# CONWAY

HISTORIC DISTRICT COMMISSION  
STAFF REPORT

5:30 pm • September 23, 2019 • City Hall

Front

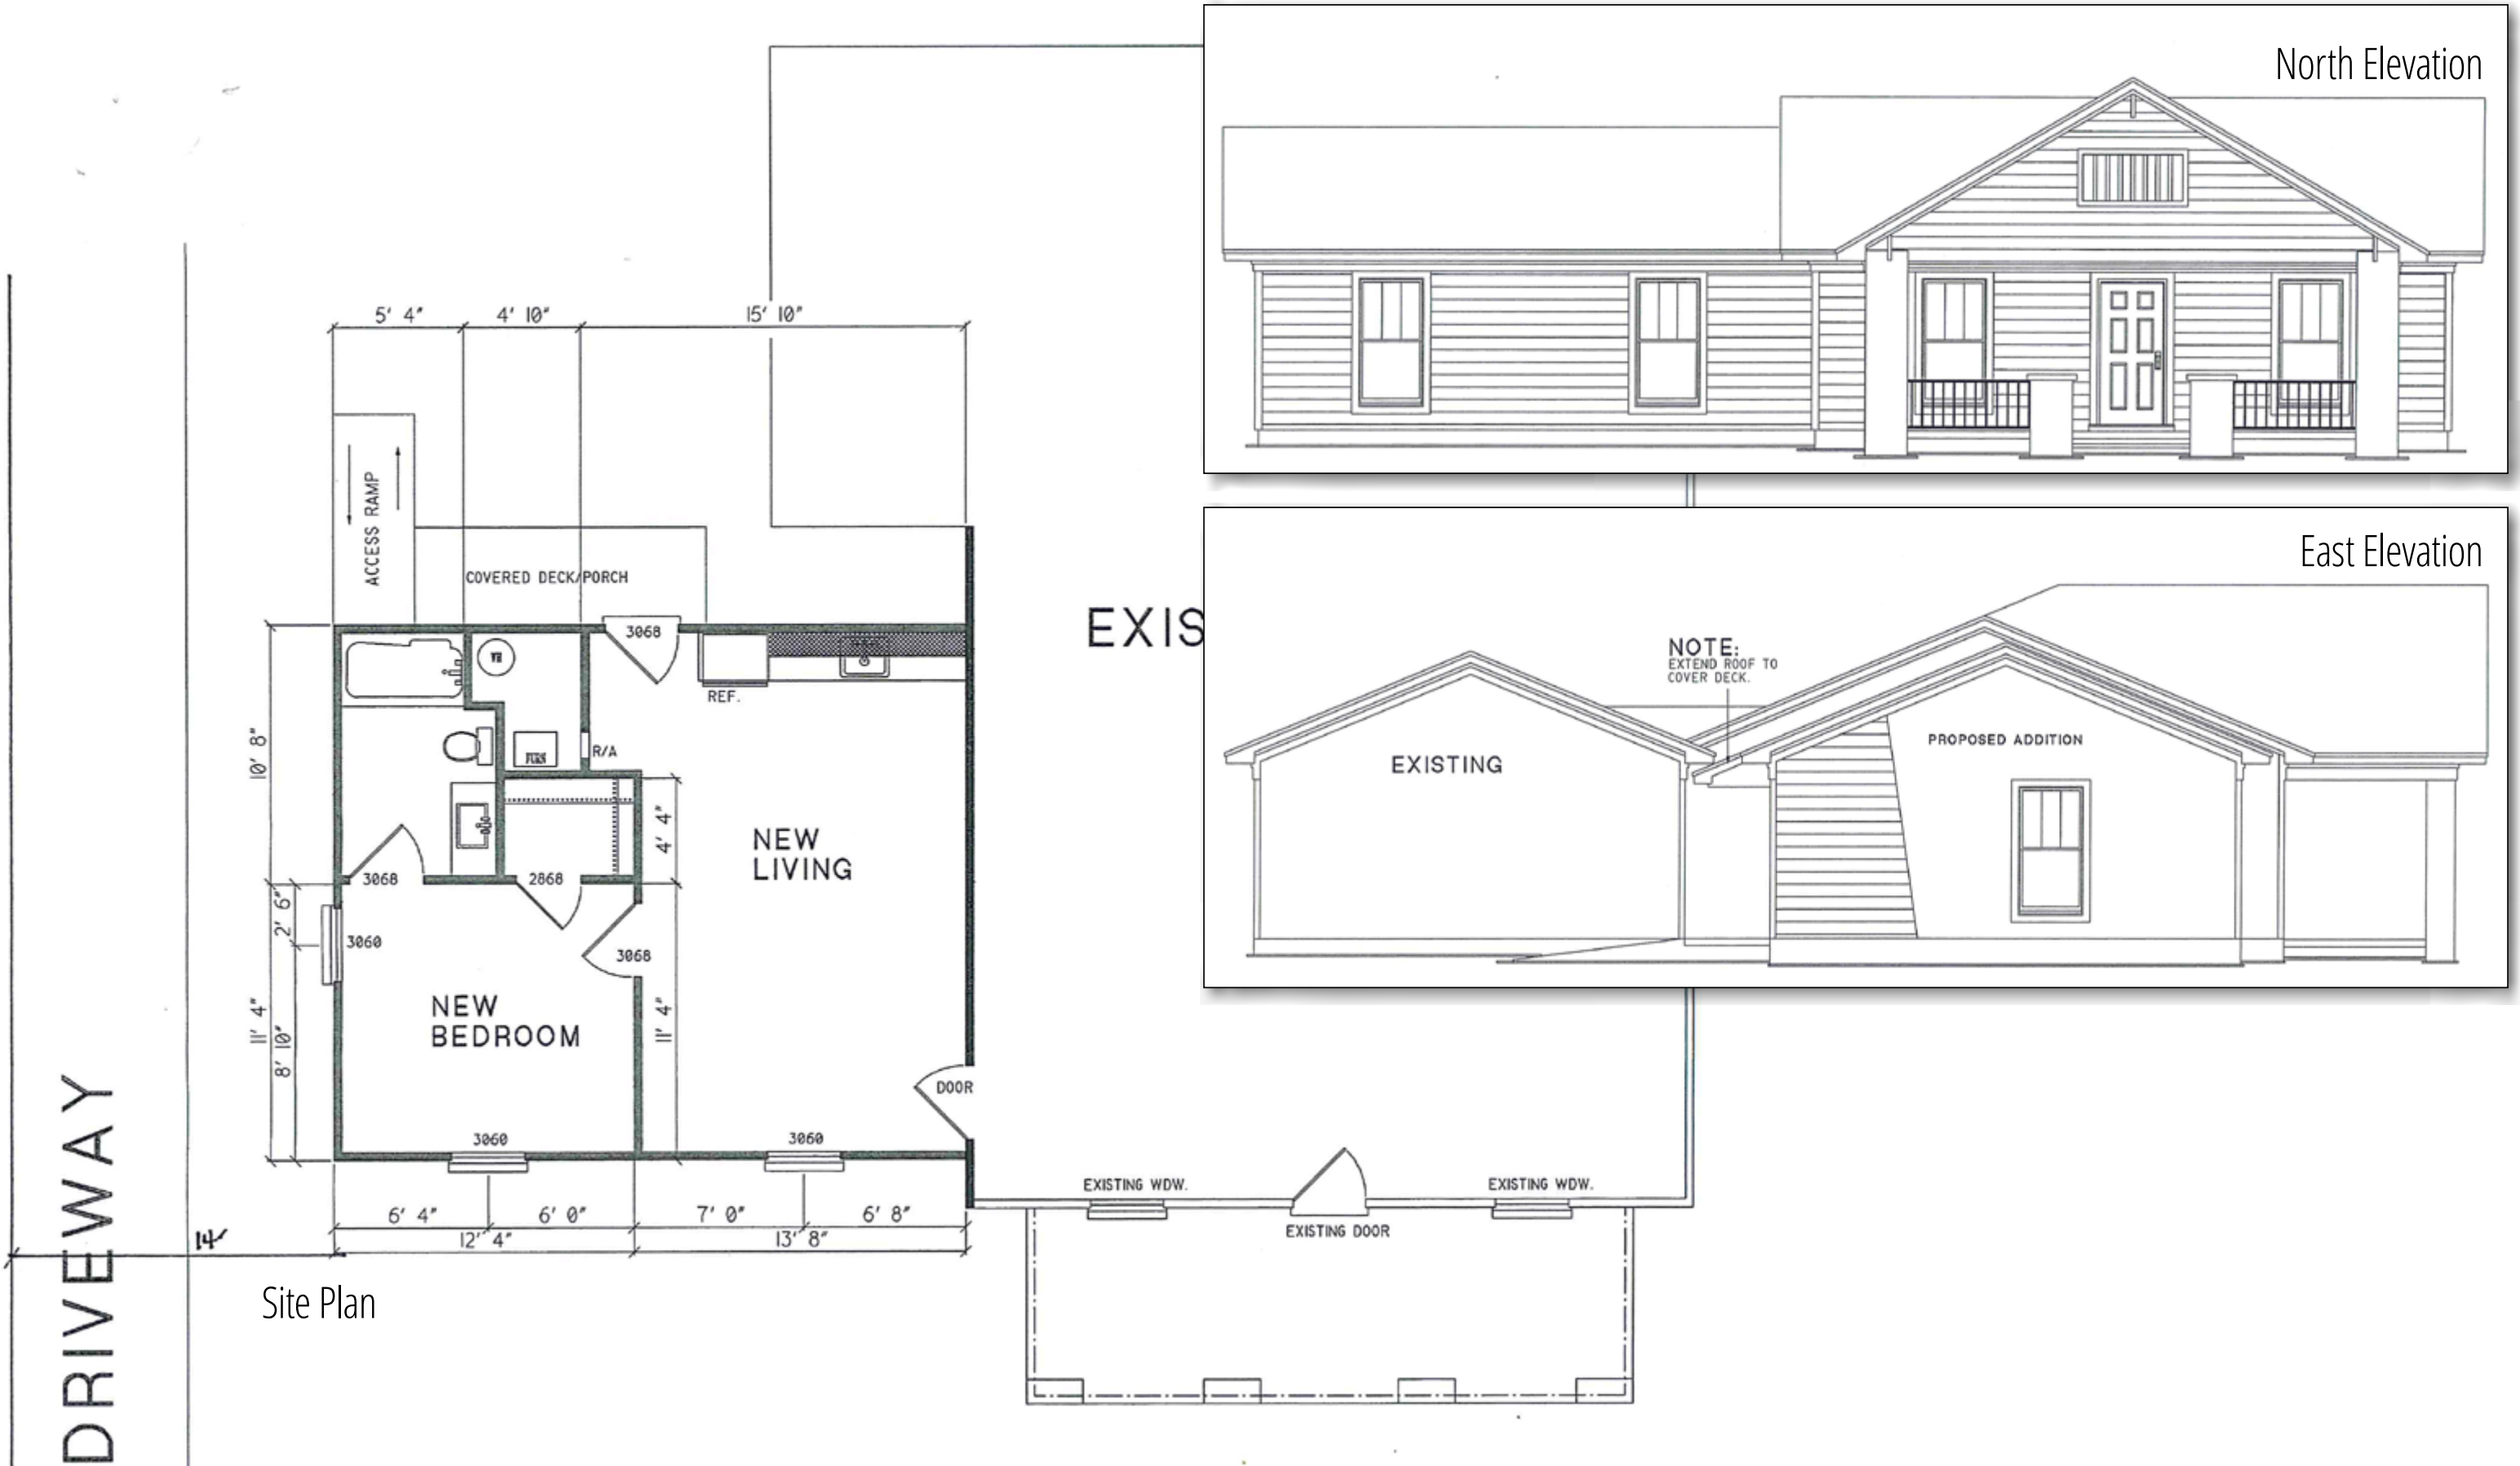
*The addition should feature similar eave brackets as are found on the rest of the house.*

*The applicant's proposal shows "3 over 1" windows with wide trim and no shutters. It is unclear if these windows are intended to be replaced. This appears to be an error as the existing windows largely appear to be "12 over 1" windows with some smaller windows as "9 over 1" windows."*

*The single window design on the east façade of the new addition should be replaced with a double window design.*

1. The applicant use wood siding and trim to match the existing siding.
2. Eave brackets to match the existing brackets types shall be used on the addition.
3. A two window opening consistent with the window form of the existing windows on the east elevation be required on the new addition.
4. New windows placed will be wood windows of a "12 over 1" design to match the existing windows and use wide trim to match existing trim on the house.
5. HVAC and utility equipment shall be appropriately located at the rear or side of the structure and/or appropriately screened.
6. The applicant will provide revised plans to the Planning Director for review and approval prior to issuance of building permits.

Front

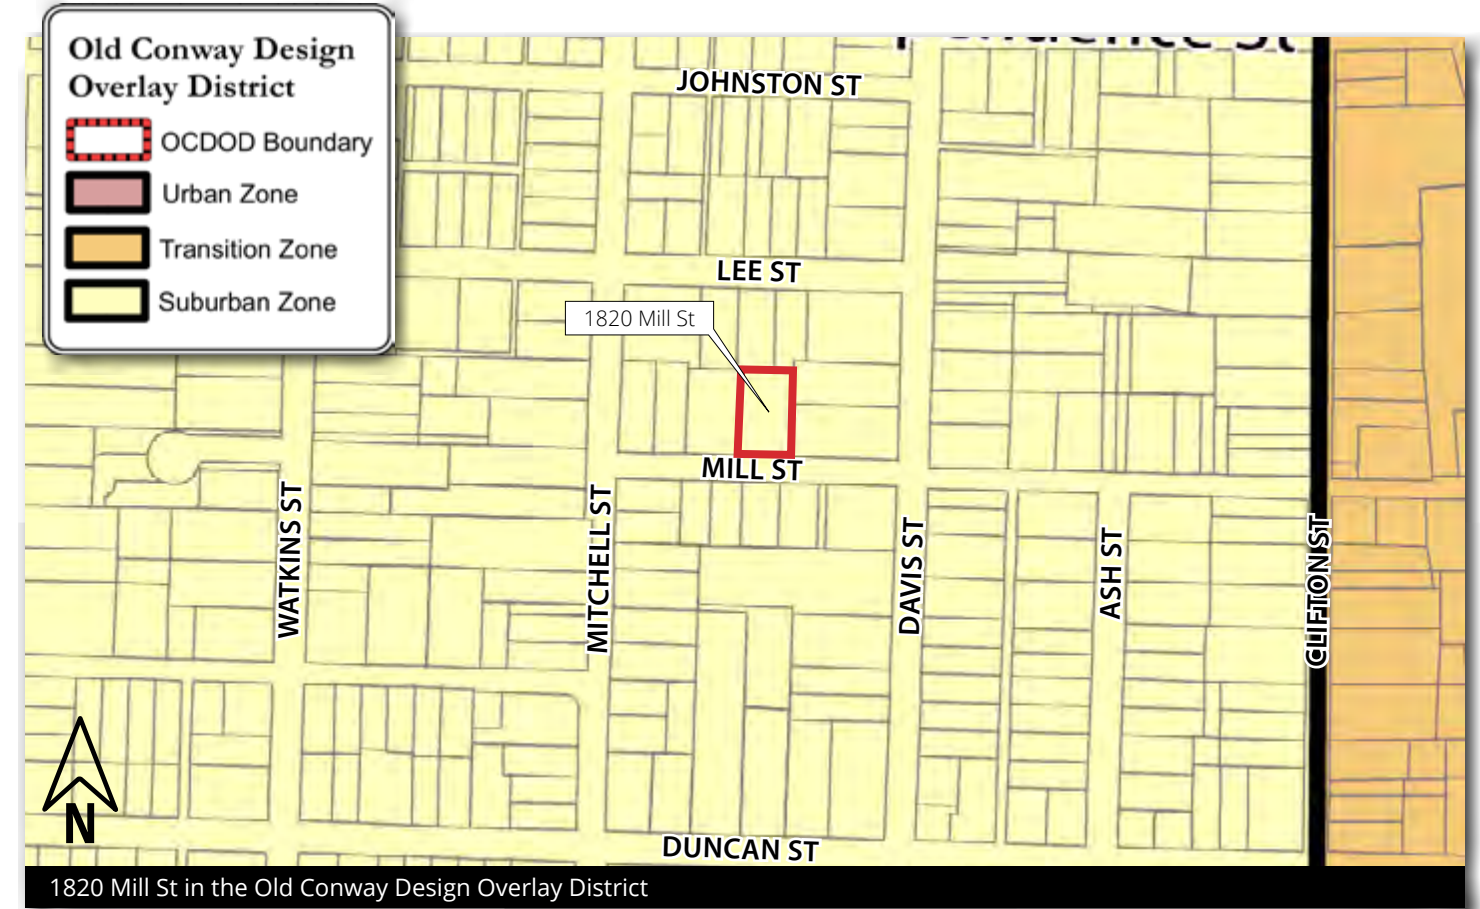
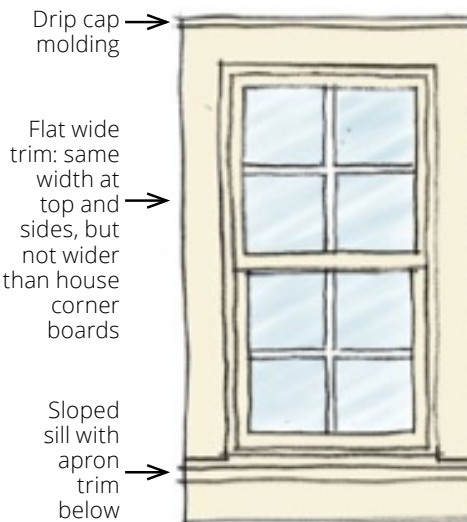
*Multiple windows have been removed and replaced with windows that do not fill the existing window openings. Recommend requiring that all areas where windows have been replaced that flat, wide trim be added back to match the previous window openings. Where windows have been removed and replaced with plywood, recommend requiring windows be placed that fill the full void of the window opening and flat, wide trim be added back to match the previous window openings.*

*The structure has existing narrow wood siding, and the applicant is proposing to repaint the existing wood siding. Such work is*

*appropriate, recommend requiring that all appropriate trim work be required as part of the project.*

- All areas where windows have been replaced that flat, wide trim be added back to match the previous window openings.
- Where windows have been removed and replaced with plywood, windows shall be placed that fill the full void of the window opening and flat, wide trim be added back to match the previous window openings.
- As part of painting the structure, replacement of all appropriate trim work be conducted as part of the project.

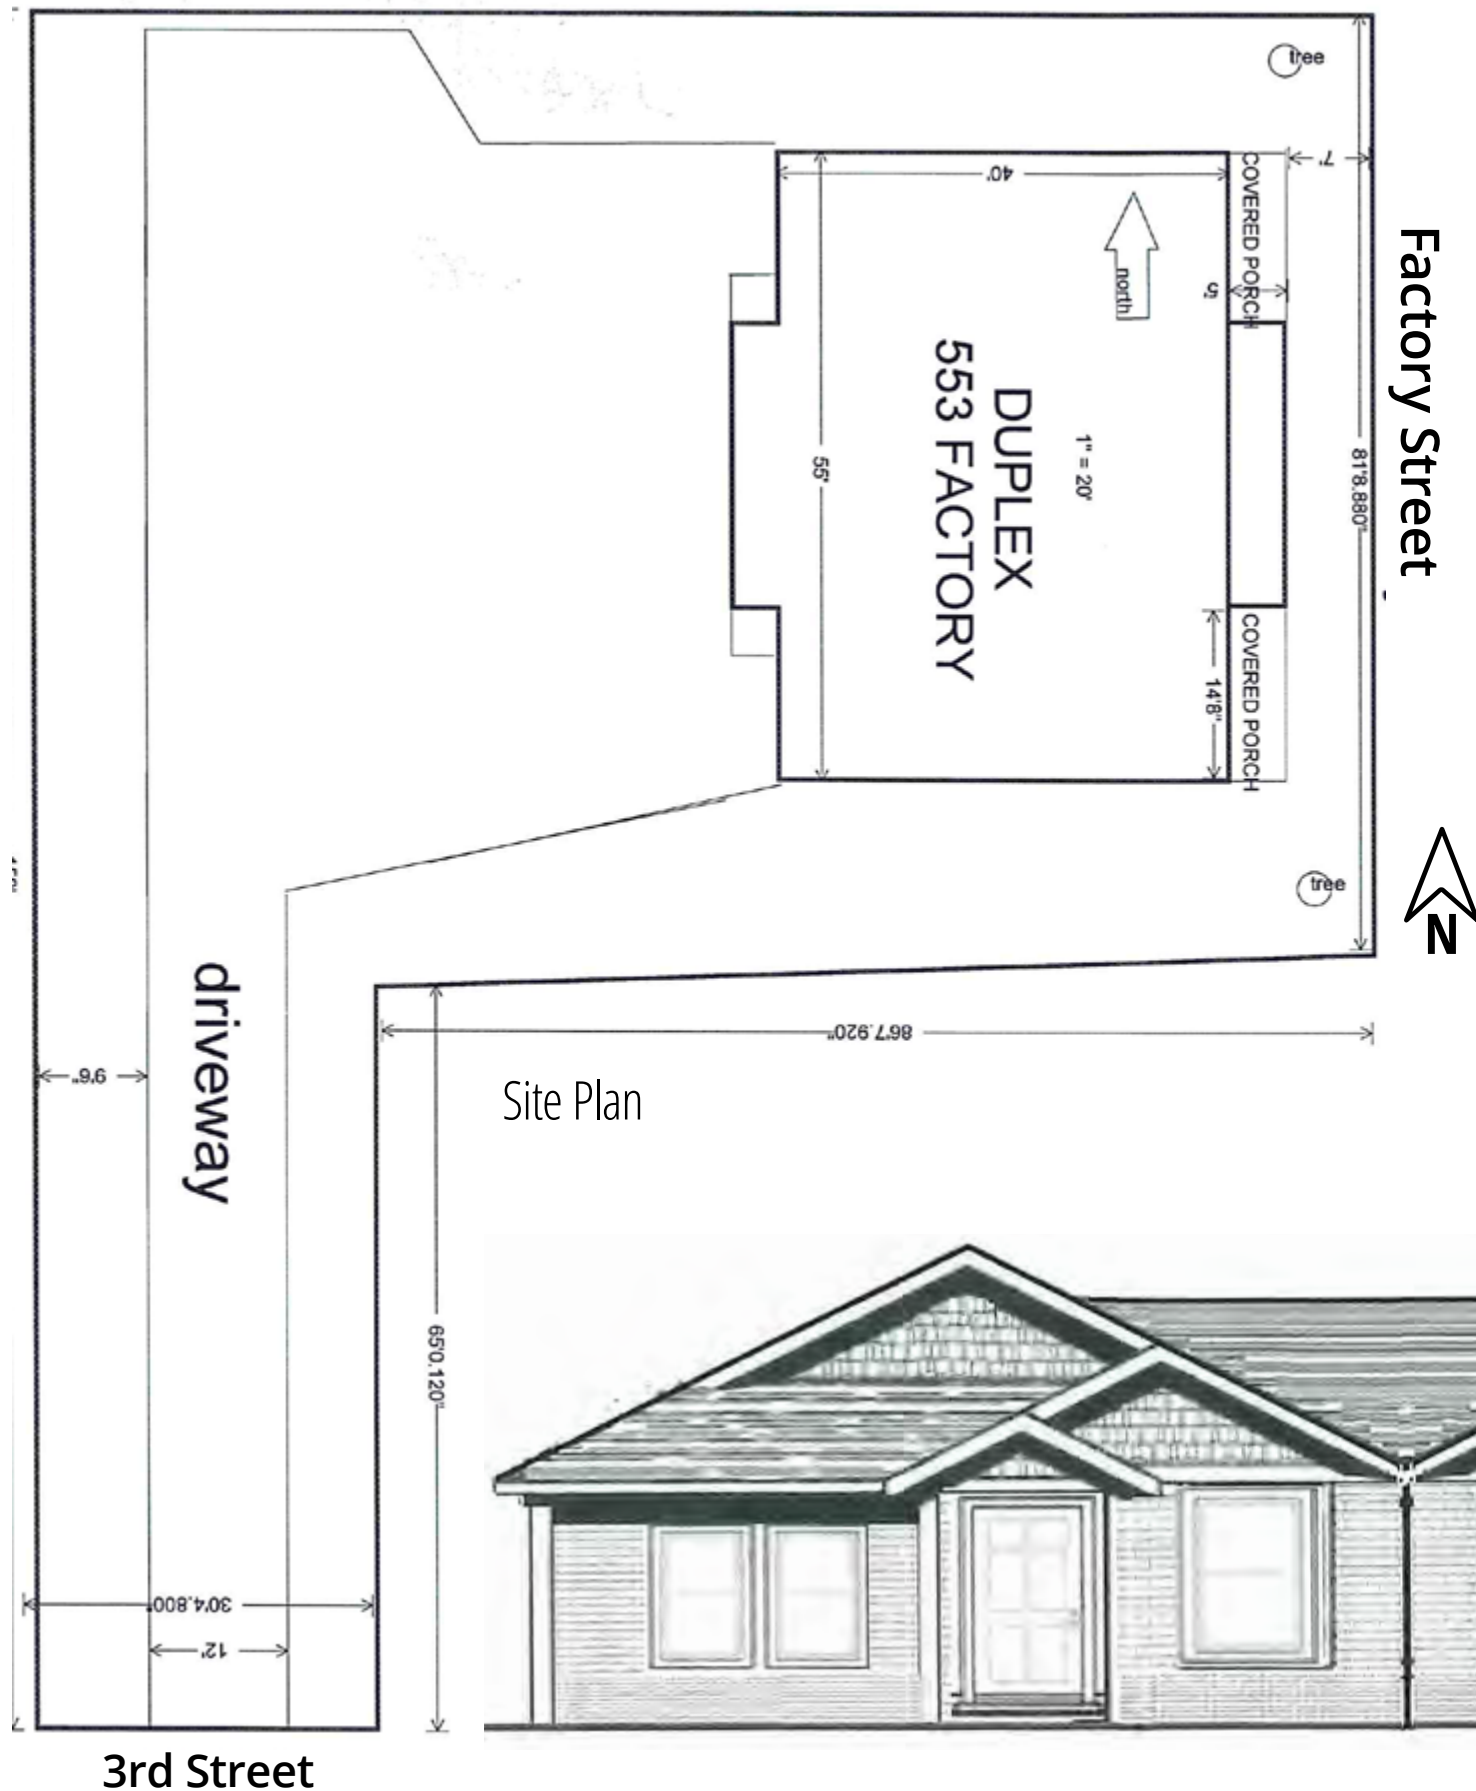
with the Transition District standards.  
*To mitigate the visual impact of the driveway, it is recommended a condition of requiring a canopy tree on each side of the driveway be required for screening.*

*Staff recommends minimum requirements be imposed as a condition of approval.*

*Recommend requiring that HVAC not be placed at the front of the house.*

1. Driveway shall be paved with concrete, or appropriate pervious pavers. Two canopy trees planted on each side of the driveway shall be provided to reduce visual impact from 3rd St frontage.
2. Exterior materials shall be brick/stone.
3. HVAC equipment be placed in a manner to minimize its visibility from the street.
4. The applicant will provide revised plans to the Planning Director for review and approval prior to issuance of building permits. This shall include resolving discrepancies between the plan view and elevations.
